Access Compliance Report

Public Rights-of-Way

(Curb Ramps)

Intersection ID: 28698	Main Street: OLD_LITTLE_ROCK_RD	Cross Street: N/A	Location: SW
ADA ID: 4C4FC6D725C5	Ramp Type: BlendTrans1	Initial Pass/Fail: Fail	Overall Compliance: No
Severity Score: 8.75			
Codes/Mitigation Info/Possible Solution		Field Measurements/Component Compliance

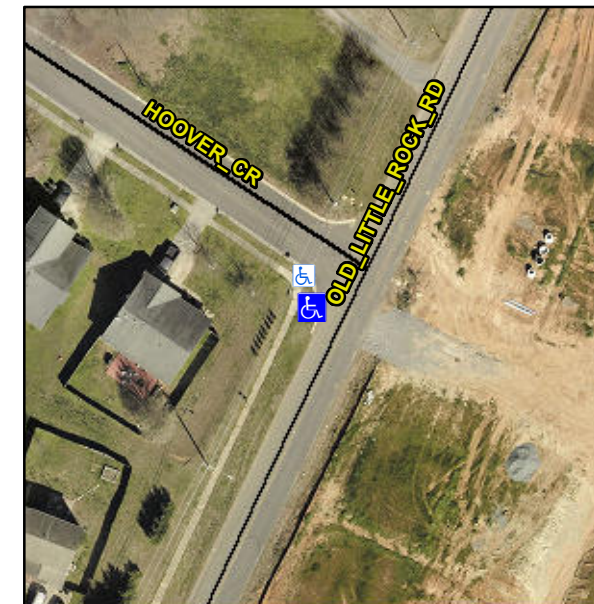
Not Found, R304.5.1

Compliance	Description	Data	Compliance	Description	Data
N/A	Ramp Length (in)	52.0	Yes	BlendTrans Slope (%)	3.8
No	Ramp Width (in)	47.5	Yes	BlendTrans XSlope (%)	1.8
N/A	Flare Type LT	N/A	N/A	Flare Type RT	N/A
N/A	Flare Slope LT (%)	N/A	N/A	Flare Slope RT (%)	N/A
N/A	Flare Traversable LT?	N/A	N/A	Flare Traversable RT?	N/A
N/A	Landing Length (in)	N/A	N/A	DWS Provided?	N/A
N/A	Landing Width (in)	N/A	N/A	DWS Contrast?	N/A
N/A	Landing Slope (%)	N/A	N/A	DWS Length (in)	N/A
N/A	Landing X Slope (%)	N/A	N/A	DWS Full Width?	N/A
N/A	Landing Curb? (Y/N)	N/A	N/A	DWS Offset (in)	N/A
N/A	Shared Landing?	N/A			
N/A	Gutter Ponding?	N/A	N/A	Gutter Slope (%)	N/A
N/A	Gutter Lip Ht (in)	N/A	N/A	Gutter X Slope (%)	N/A
N/A	Painted X Walk1?	No	N/A	Painted X Walk2?	N/A
	X Walk 1 Direction	To E		X Walk 2 Direction	N/A
	X Walk 1 Width (in)	N/A		X Walk 2 Width (in)	N/A
	X Walk 1 Slope (%)	3.6		X Walk 2 Slope (%)	N/A
	X Walk 1 X Slope (%)	0.1		X Walk 2 X Slope (%)	N/A

N/A	Ramp inside XWalk1?	N/A	N/A	Ramp inside XWalk2?	N/A
	Road Slope (%)	0.1		Clear Space?	N/A
	Road X Slope (%)	3.6	N/A	Clear Space to XWalk (in)	N/A
N/A	Any Obstructions?	N/A	N/A	Storm Grate/Utility Hazard?	N/A
	Obstruction Type			Storm Grate/Utility Type	
		N/A			N/A
			Yes	Surface Condition? (G/P)	Good
			No	Curb Slope (%)	11.4

Remove & Replace Curb Ramp With Two New Directional Ramps or Equivalent.
